ADDENDUM NO. 01

MADISON CENTRAL HIGH SCHOOL BASEBALL FACILITY

Madison, Mississippi
WBA Proj.# 2416

A1.1

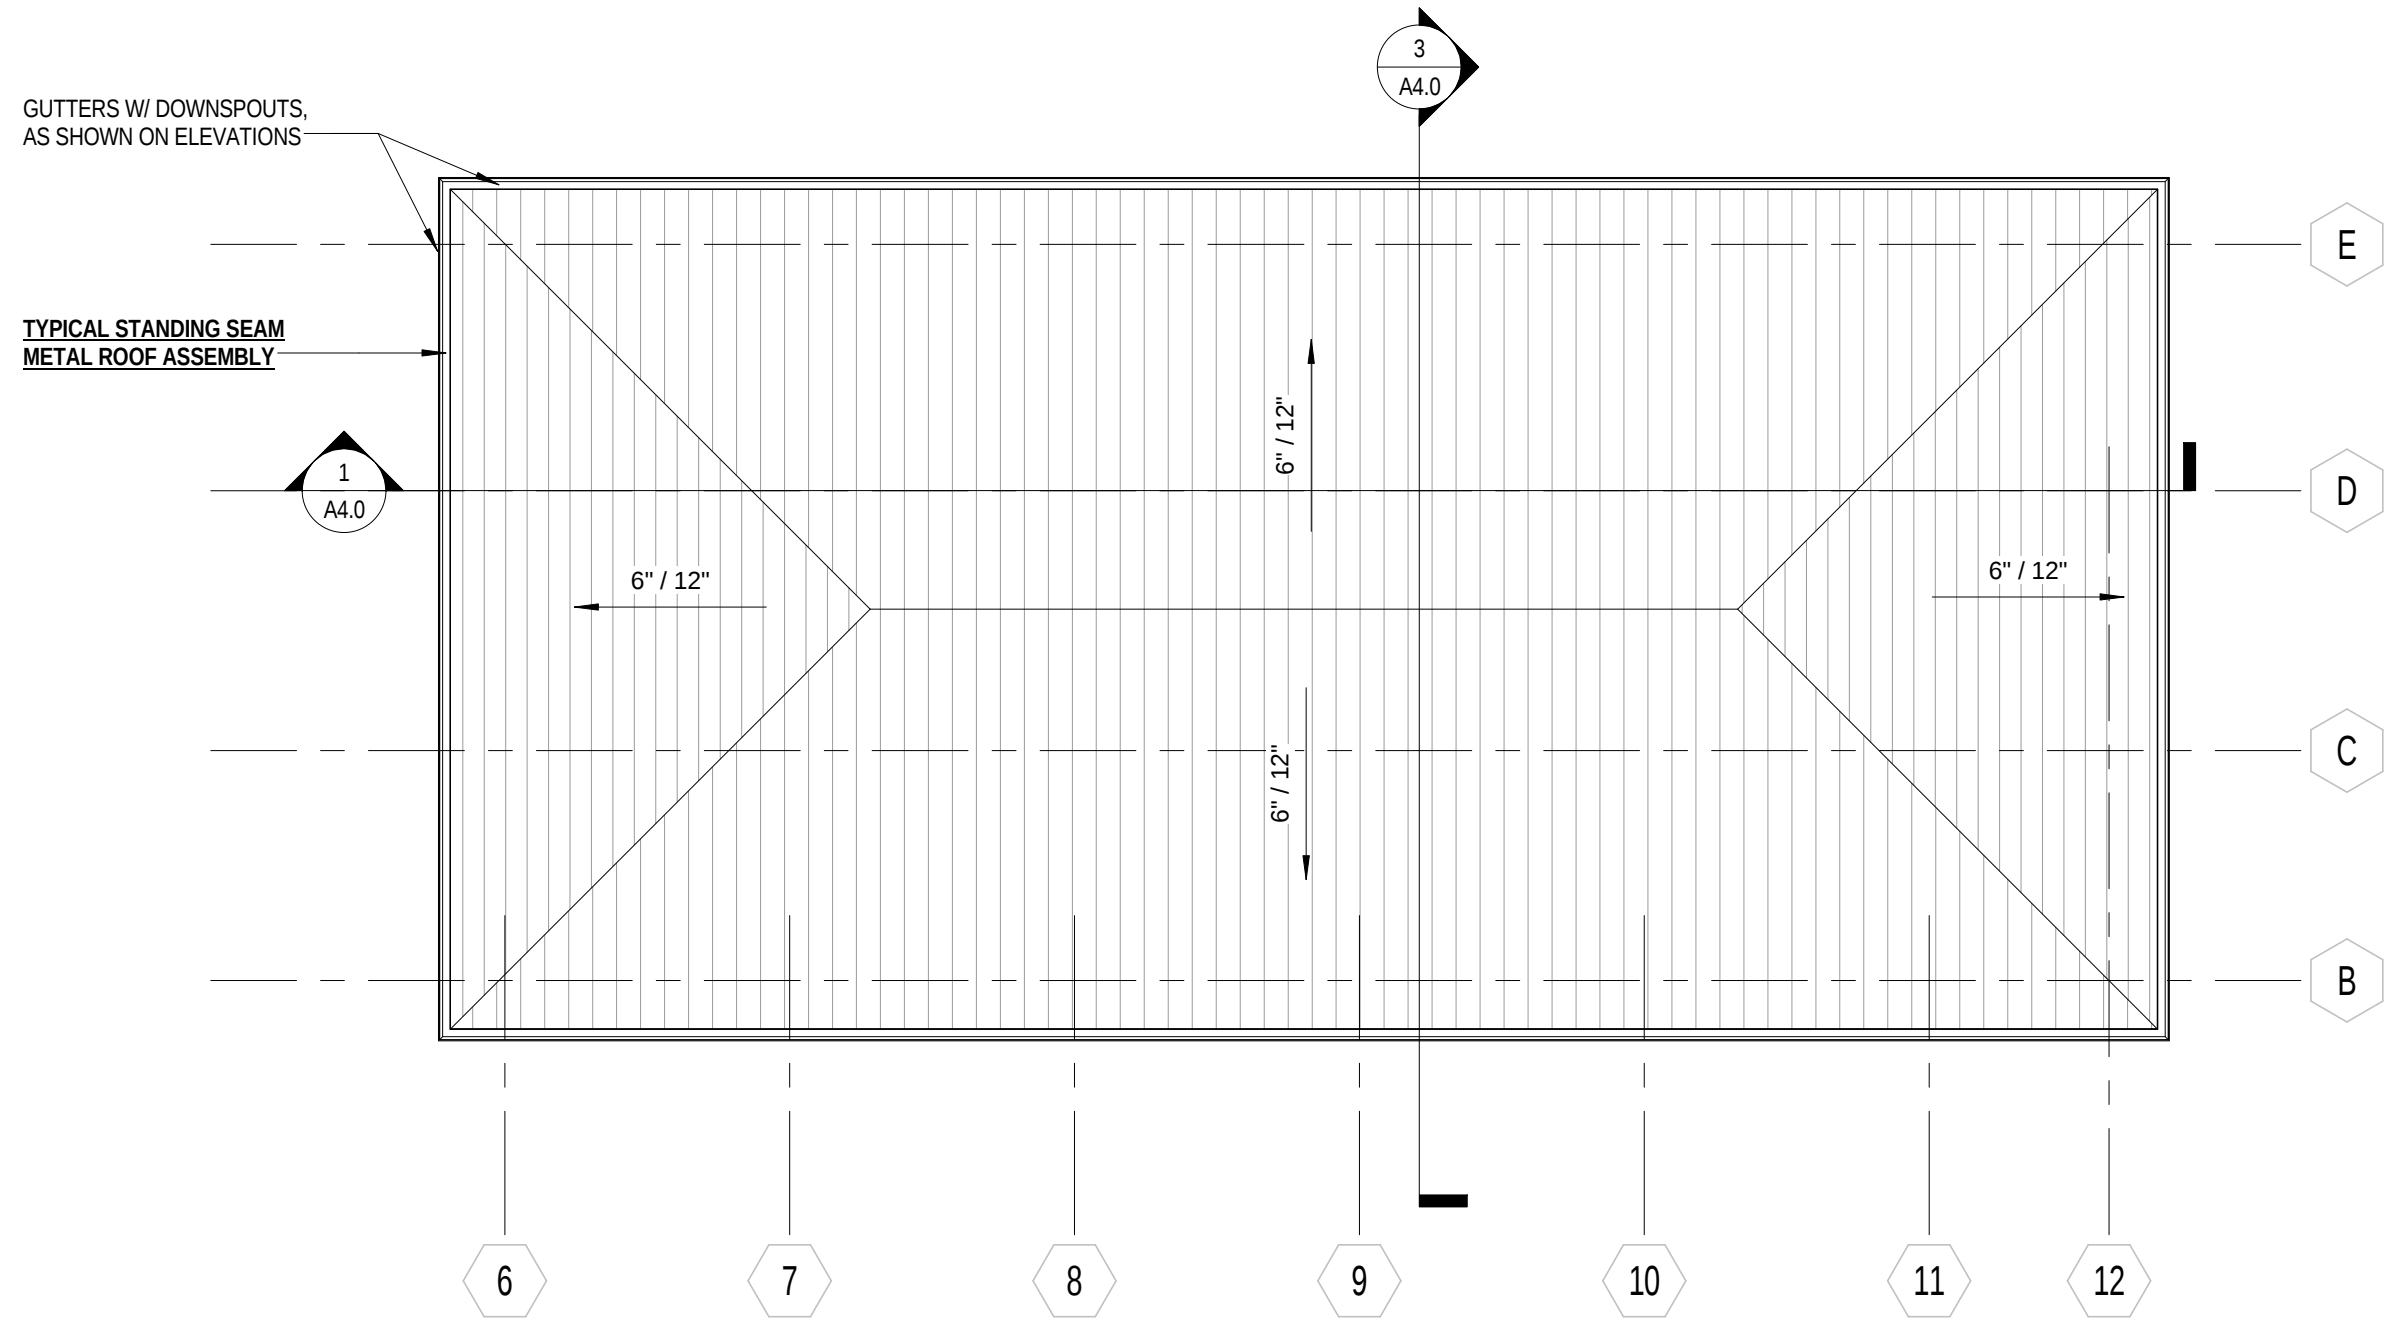
- ITEM NO. 6** **A1.1 FLOOR PLANS**
Dwg. 1 Level 1 Floor Plan
REVISE floor plan, per enclosed sheet A1.1

2 Level 2
1/8" = 1'-0"

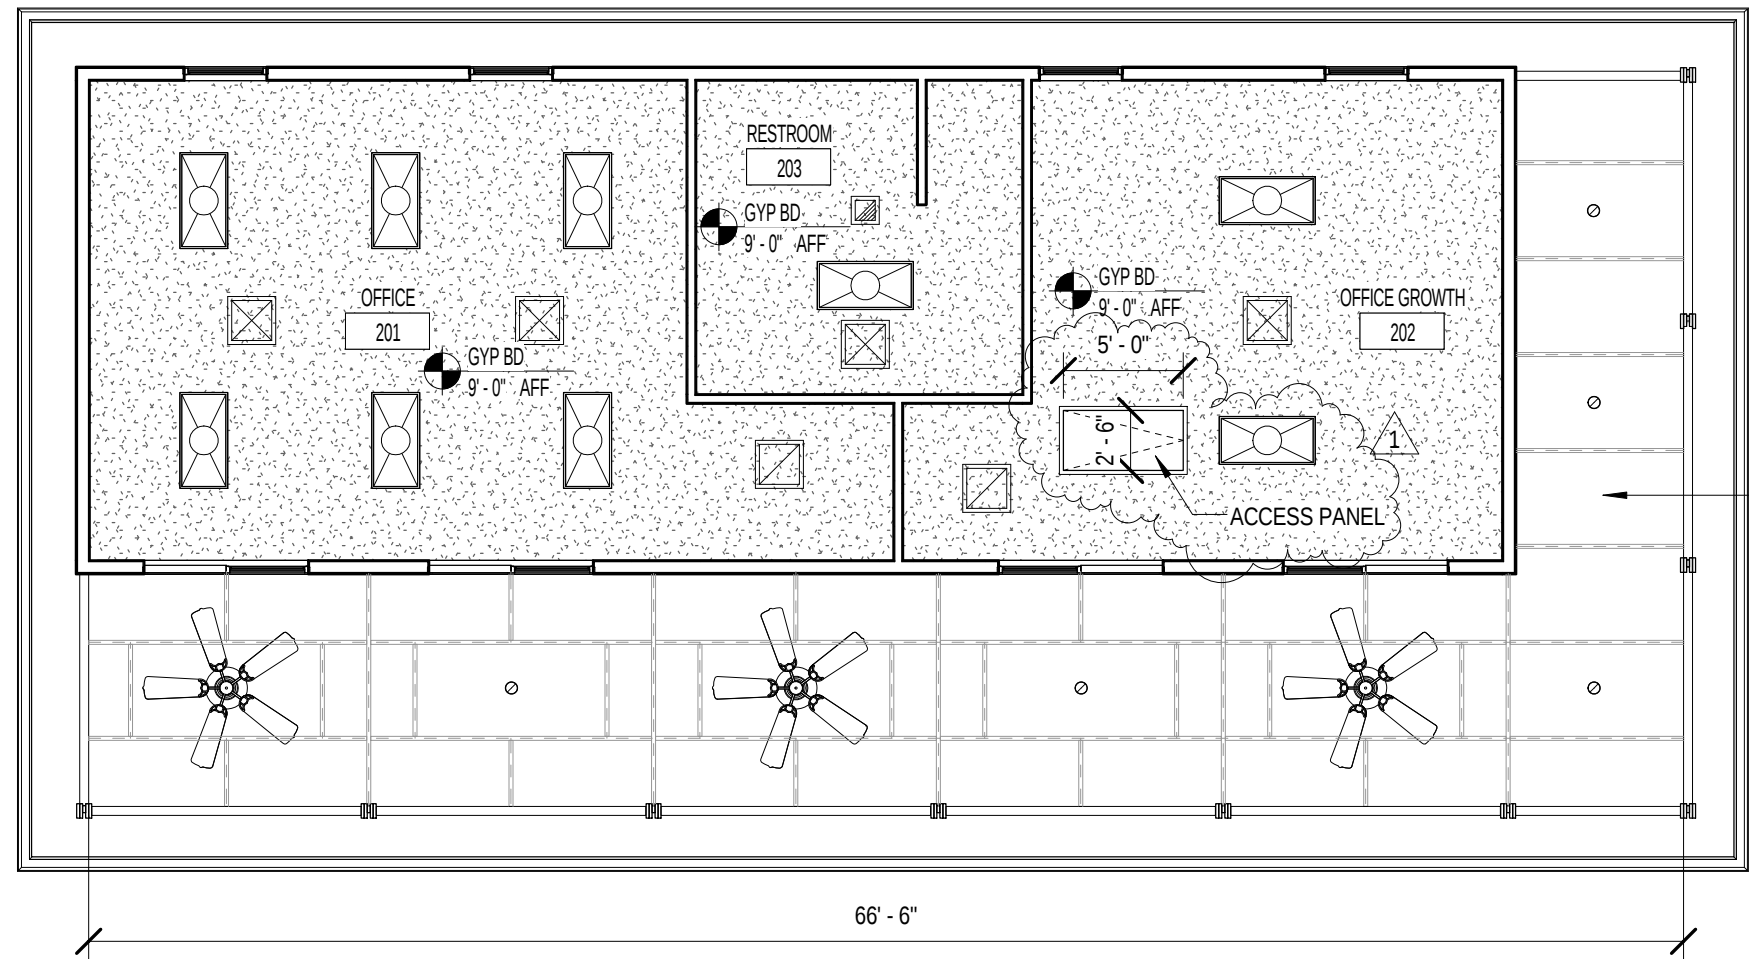
- ITEM NO. 7** **A2.0 REFLECTED CEILING PLAN**
Dwg. 2 Level 2 RCP
ADD notes and dimensions, per enclosed sheet A2.0

FOUNDATION PLAN
3/16" = 1'-0"

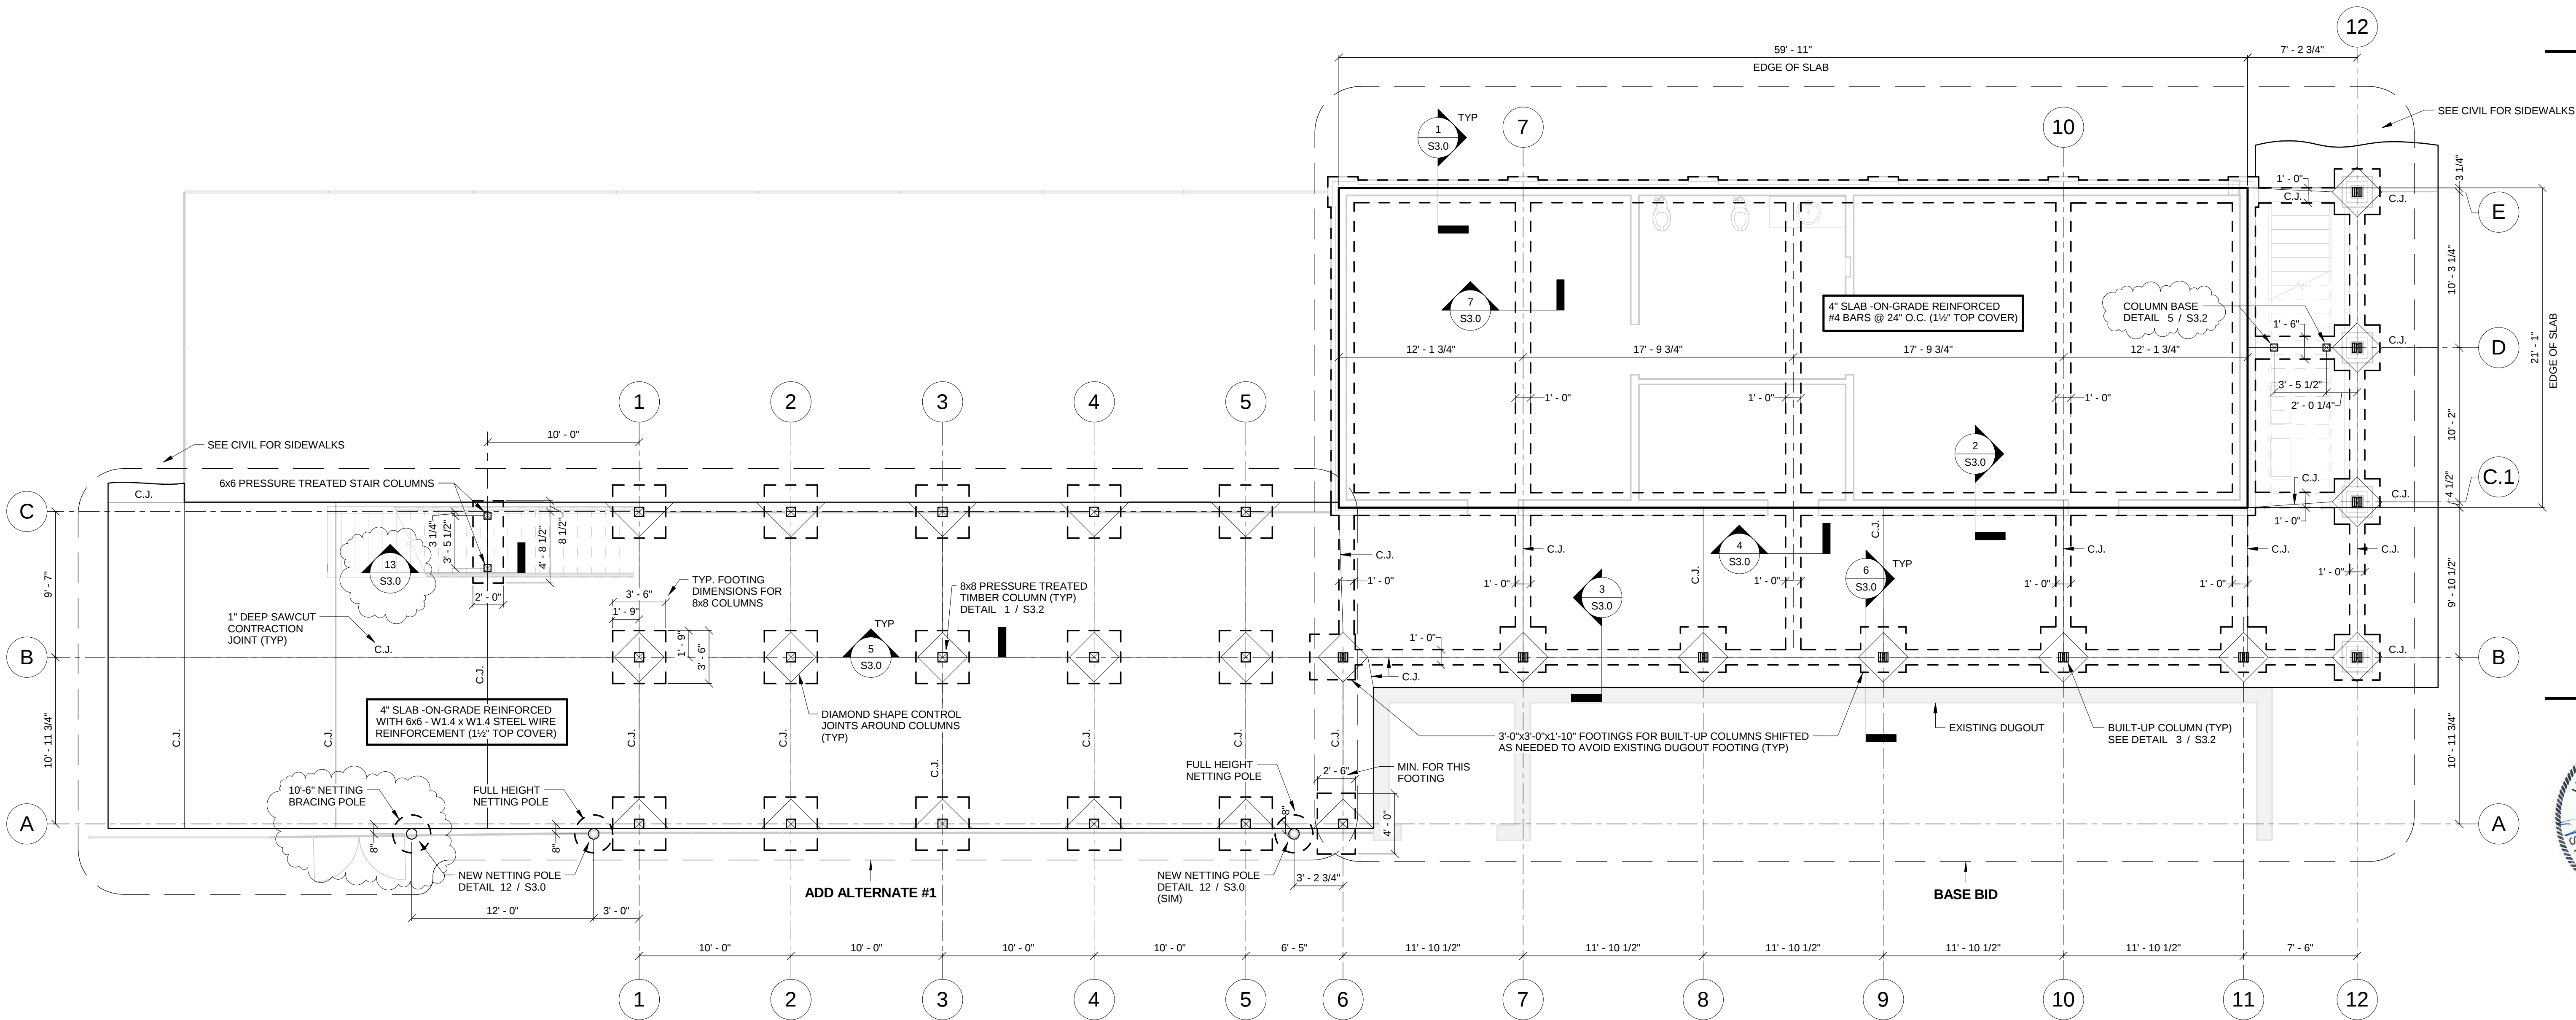
- ITEM NO. 9** **S2.0 FOUNDATION PLAN**
ADD netting bracing pole, stair column footing section marker, and stair column base connection callout, per enclosed revised sheet S2.0

1
S3.2
COLUMN BASE CONNECTION - 8x8
1 1/2" = 1'-0"

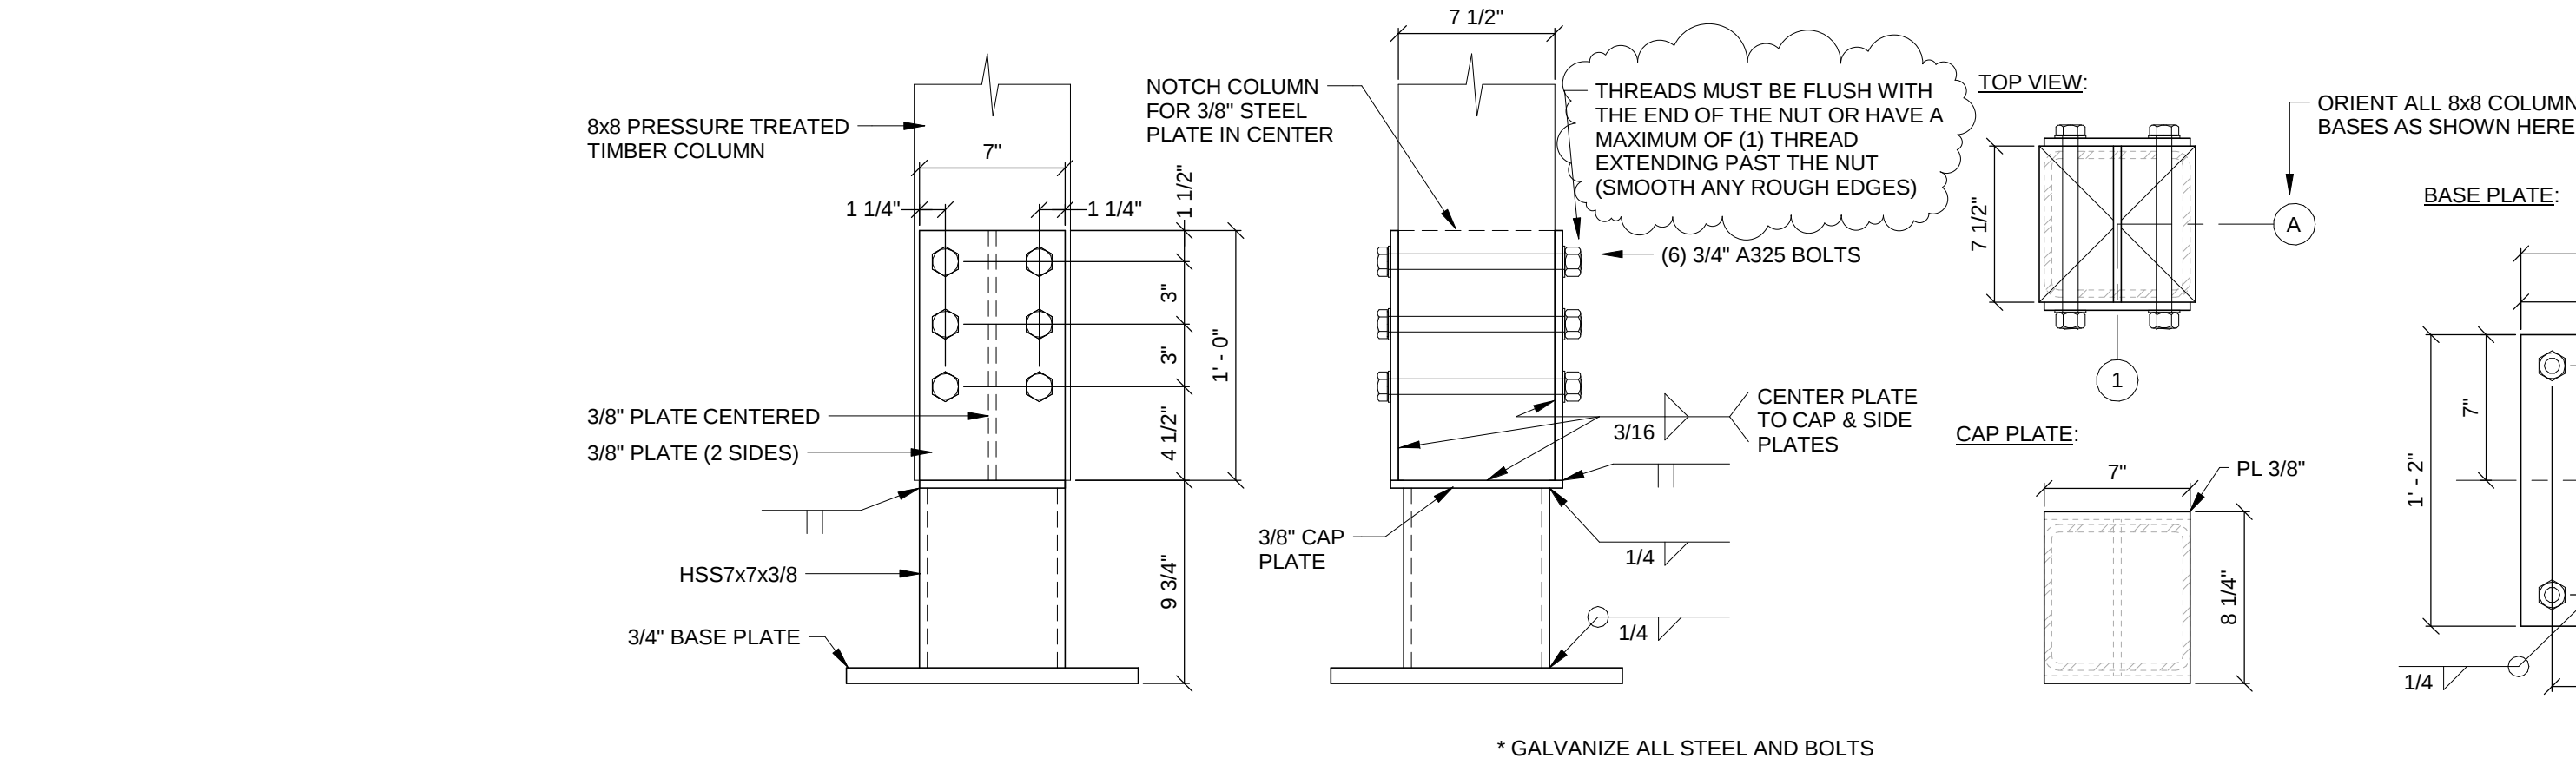
REVISE details 1, 2, & 3 to limit thread extension past nut, per enclosed revised sheet S3.2
